Model: Stinger-C1L		Date: 30-Nov-99	No.: RB001001
Subject: Differences from Stinger-C1		Prepared by: K. Miura	
From: Technical Services Dept., GTS Division			
Classification:	<input type="checkbox"/> Troubleshooting	<input type="checkbox"/> Part information	<input type="checkbox"/> Action required
	<input type="checkbox"/> Mechanical	<input type="checkbox"/> Electrical	<input checked="" type="checkbox"/> Service manual revision
	<input type="checkbox"/> Paper path	<input type="checkbox"/> Transmit/receive	<input type="checkbox"/> Retrofit information
	<input type="checkbox"/> Other ()

The new model, "Stinger-C1L (B001)" will be launched in January 2000. It is a slightly modified version of the already existing model "Stinger-C1 (Ricoh Aficio 180, Gestetner 3218, Nashuatec D418, Rex-Rotary 2818, Savin 9918DP, Infotec 4180 MF)".

This RTB clarifies the differences between the base copier and Stinger-C1L (based on the style of the service manual).

***1-3. PAPER PATH**

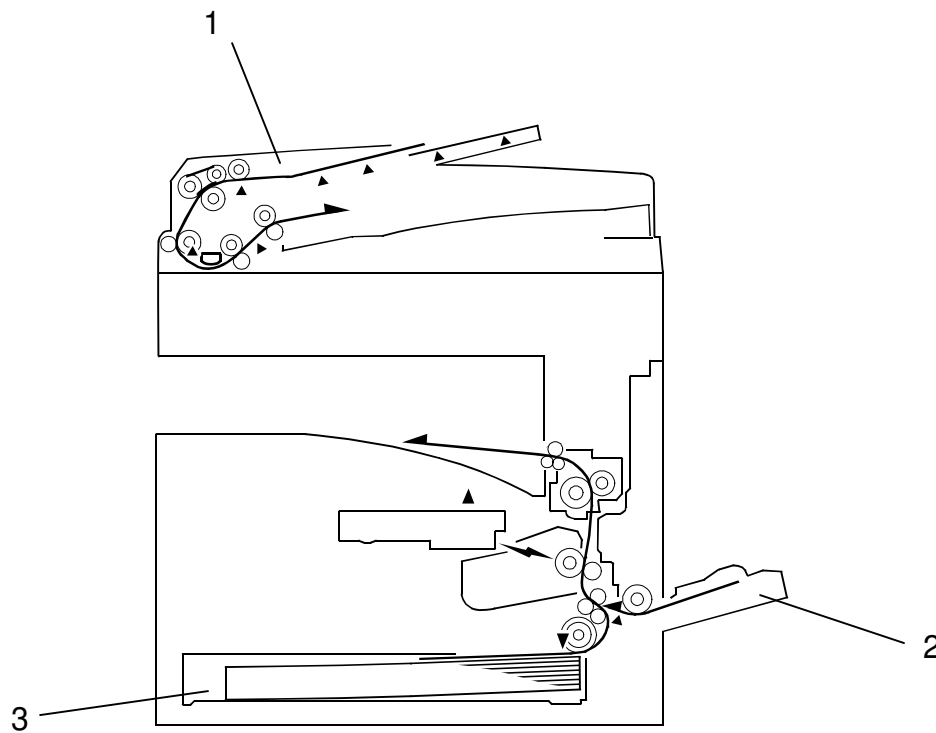
*1-2. MACHINE CONFIGURATION

Version	Item	Machine Code	No.
Copier	Copier	B001	B
	ADF (Optional)	A859	A
	Platen Cover (Optional)	A893	
	Memory 48 MB (Optional)	A887	
Printer	Printer Controller (Optional)	B305	
	PS Option (Optional)	B308	
	HDD (Optional)	G690	
	NIB (Optional)	B307	
	Memory 32 or 64 MB (Optional)	G688

1-4. ELECTRICAL COMPONENT DESCRIPTIONS

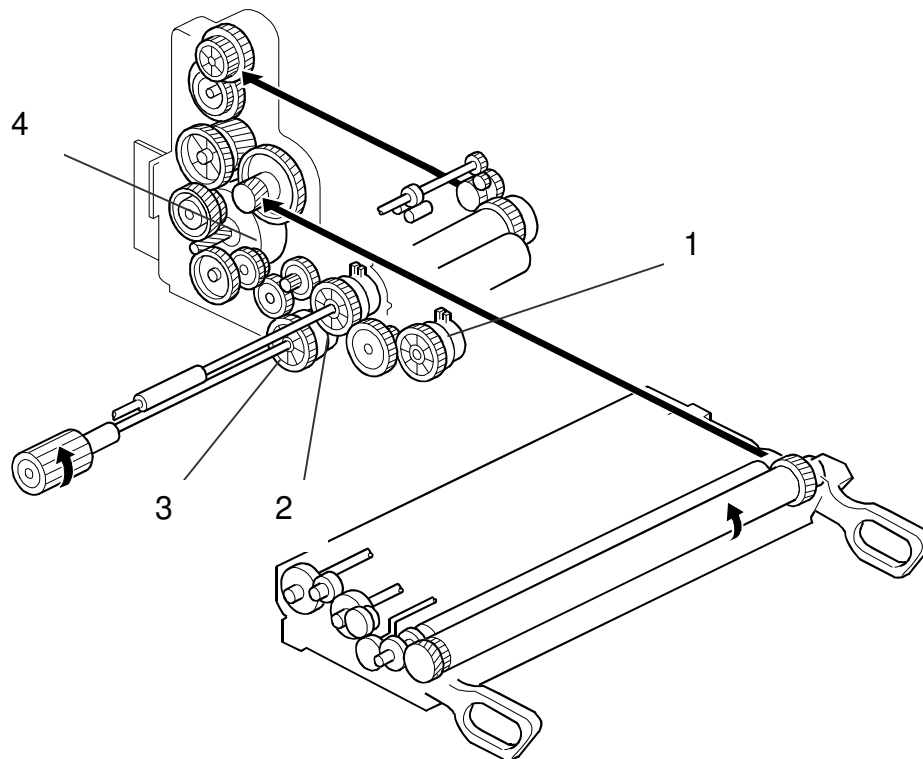
The following items are not included in this machine.

Symbol	Name	Function	Index No.
MC4	Registration	Drives the registration rollers	13
SW4	Vertical Transport Cover Switch	Detects if the front door is open or not, and cuts the +24 V DC power line for the vertical transport clutch.	25
S10	Vertical Transport	Detects misfeeds.	22
PCB10	FCU (Option)	Controls all fax communications and fax features, in cooperation with the BICU.	43
PCB11	NCU (Option)	Switches the analog line between the fax unit and the external telephone.	47
LED1	Exit Tray	Indicates if there is paper on the exit tray.	32
LED2	1-bin Sorter	Indicates if there is paper on the 1-bin sorter. 1-bin sorter is option.	34
SP1	Speaker	Turns on during fax communication.	41
